NEW CODE REQUIREMENTS FOR ASME A17.1-2016/CSA B44-16
SECTION 5.3 PRIVATE RESIDENCE ELEVATORS

FOX VALLEY		1726 North Ballard Road Appleton, WI 54911 Phone: 800-238-8739	
ELEVATOR™			
ELEVATOR CONTRACTOR:			
JOB NAME:		ORDER NUMBER:	
2016 CODE CHANGE			
DRAWN BY:	DATE:	SIGNATURE OF APPROVAL	DWG. NO. C-003047

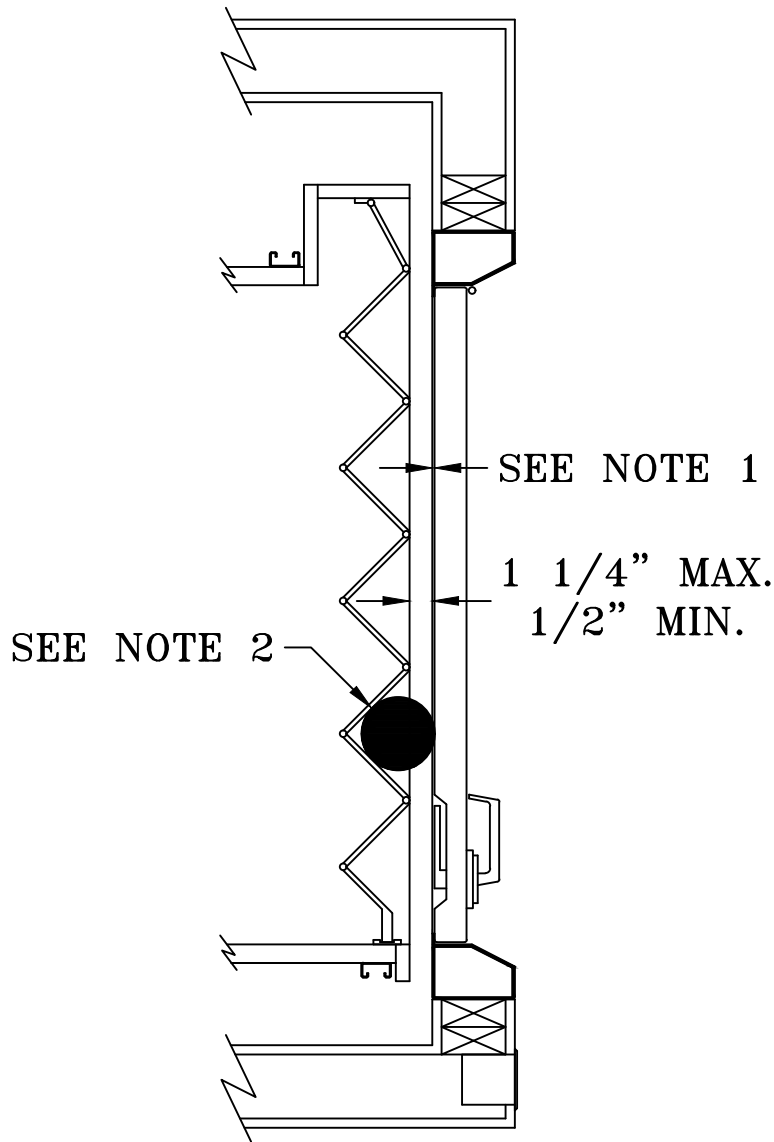
NOTE 1:
SECTION 5.3.1.7.2 CLEARANCE BETWEEN HOISTWAY
DOORS AND LANDING SILLS.

DISTANCE BETWEEN THE FACE OF THE HOISTWAY
DOOR AND EDGE OF LANDING SILL SHALL NOT
EXCEED 3/4".

NOTE 2:
SECTION 5.3.1.8.3 CLEARANCE BETWEEN HOISTWAY
DOORS AND CAR DOORS OR GATES.

MUST REJECT 4" DIAMETER BALL AT ALL POINTS
WHEN HOISTWAY DOOR AND CAR DOOR ARE IN
FULLY CLOSED POSITION.
